PCN-20210121 TE0726-03 DDR3 Change and Product Update

Company	Trenz Electronic GmbH
PCN Number	PCN-20210121
Title	TE0726-03 DDR3 Change and Product Update
Subject	BOM change
Issue Date	2021-01-25

This change affects Trenz Electronic boards TE0726 of Revision 03: TE0726-03-*

#1 Change DDR3 RAM (U8) from IM4G16D3FABG-125I to IS43TR16256BL-125KBLI

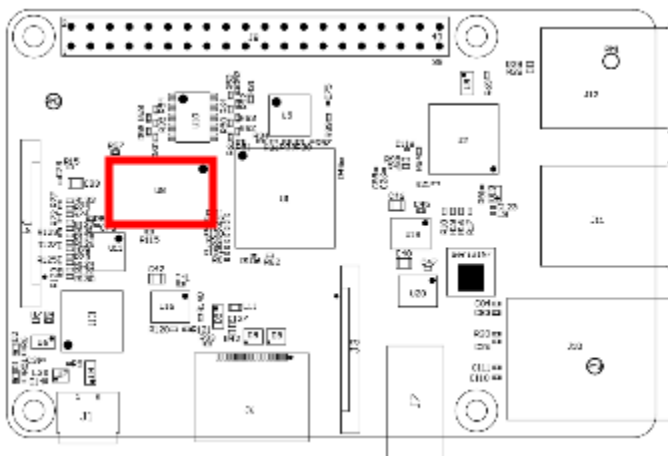
Type: BOM change

Reason: Component is end of life.

Impact: New DDR timings may be considered in designs.

Locate DDR3 RAM (U8) on top side of PCB:

old	new
IM4G16D3FABG-125I	IS43TR16256BL-125KBLI
